**Re: Application to Change existing Mining Plan, Vegetation Reference Area, Bear Canyon Mine, ACT/015/025, Task ID# 1504**

**APPLICATION FOR COAL PERMIT PROCESSING**

**VEGETATION MAP**

BEAR CANYON PLATE 9-1

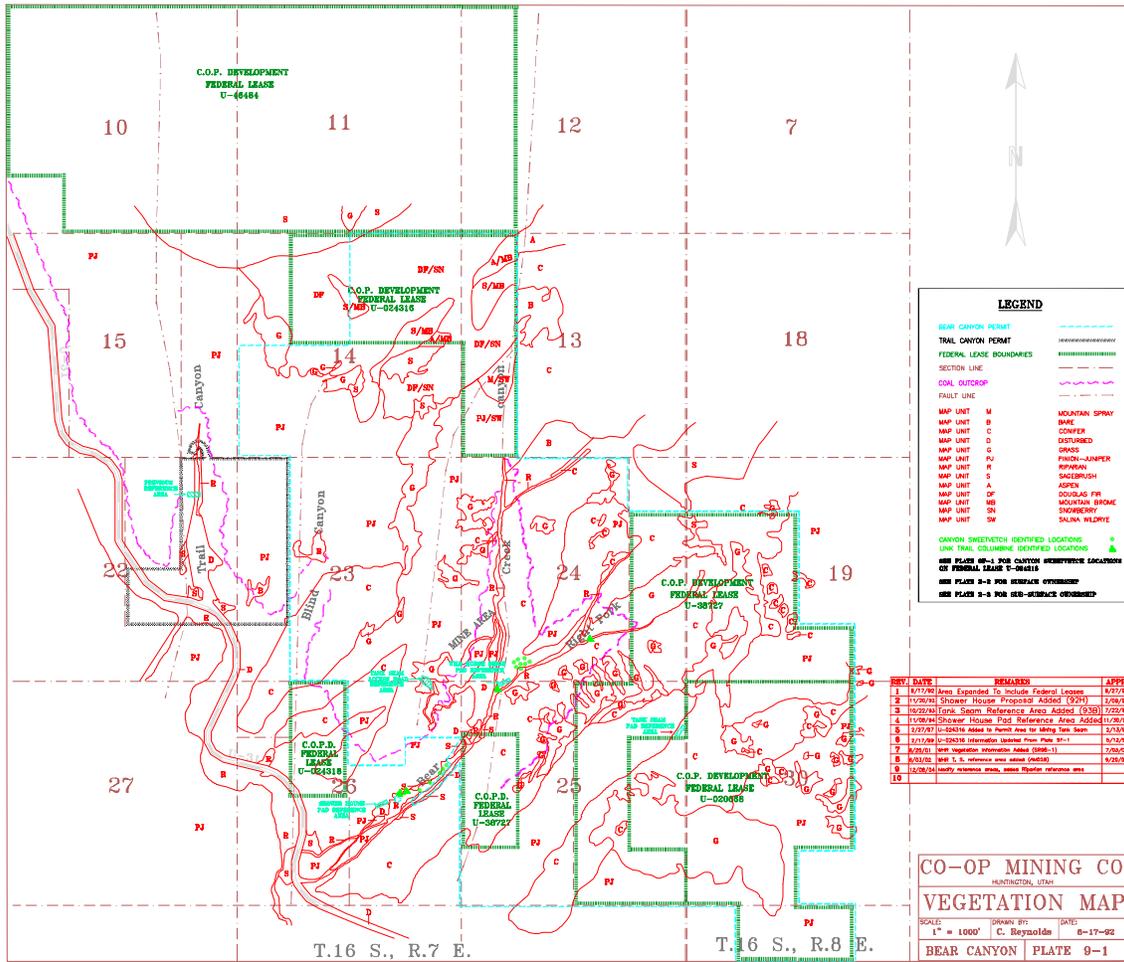
Plate 3-1 (9-1):

- Remove wording "Shower House Pad" associated with WHRidge RA.
- Add the word "Previous" to the wording "Reference Area" that pertains to the RA in Trail Canyon (section 22).
- Add the GPS area for the riparian reference area located off the Tank SAR RA.

On Plate 9-1 the wording "Shower House Pad" associated with Wild Horse Ridge reference area was removed.

Added the word "Previous" to the wording "Reference Area" that pertains to the reference area in Trail Canyon.
